Access Compliance Report

Public Rights-of-Way

(Curb Ramps)

Intersection ID: 14401	Main Street: BAXTER_ST	Cross Street: BALDWIN_AV	Location: W
ADA ID: 192D02F0DA8B	Ramp Type: PerpDiag	Initial Pass/Fail: Fail	Overall Compliance: No
		Severity Score: 1.25

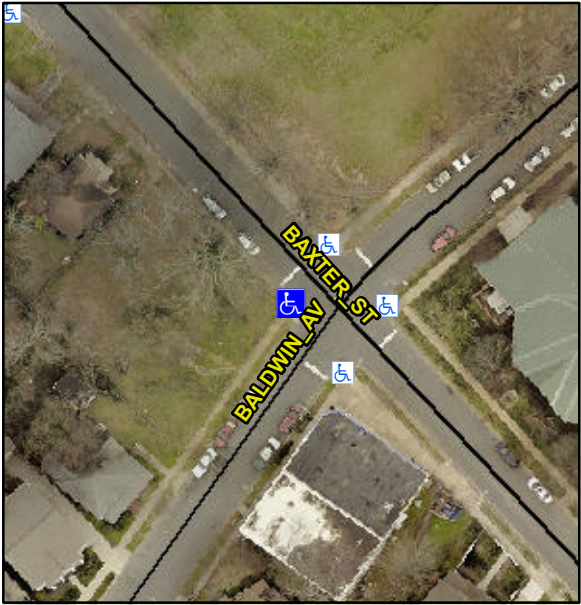
Codes/Mitigation Info/Possible Solution			Field Measurements/Component Compliance		
	Possible Solutions:		Compliance	Description	Data
	Remove & Replace Curb Ramp With Two New Directional Ramps or Equivalent.		Yes	Ramp Length (in)	95.0
			N/A	Ramp Width (in)	51.0
			N/A	Flare Type LT	N/A
			N/A	Flare Slope LT (%)	N/A
			N/A	Flare Traversable LT?	N/A
			N/A	Flare Type RT	N/A
			N/A	Flare Slope RT (%)	N/A
			N/A	Flare Traversable RT?	N/A
			N/A	DWS Provided?	N/A
			N/A	DWS Contrast?	N/A
			N/A	DWS Length (in)	N/A
			N/A	DWS Full Width?	N/A
			N/A	DWS Offset (in)	N/A
			N/A	Shared Landing?	N/A
<p>Surveyor Notes:</p> <p>N/A</p> <p>PROW/ADA:</p> <p>Not Found, R304.5.3</p>			N/A	Gutter Ponding?	N/A
			N/A	Gutter Lip Ht (in)	N/A
			N/A	Gutter X Slope (%)	N/A
			No	Painted X Walk1?	No
			To SE	X Walk 2 Direction	To NE
			N/A	X Walk 2 Width (in)	N/A

3.7	X Walk 2 Slope (%)	3.0
			1.2	X Walk 2 X Slope (%)	1.6
			N/A	Ramp inside XWalk2?	N/A
			N/A	Ramp inside XWalk1?	N/A
			0.0	Clear Space?	N/A
			5.0	Clear Space to XWalk (in)	N/A
			N/A	Storm Grate/Utility Hazard?	N/A
			N/A	Storm Grate/Utility Type	N/A
			N/A	Surface Condition? (G/P)	Good
Total Cost:		\$ 3200.00
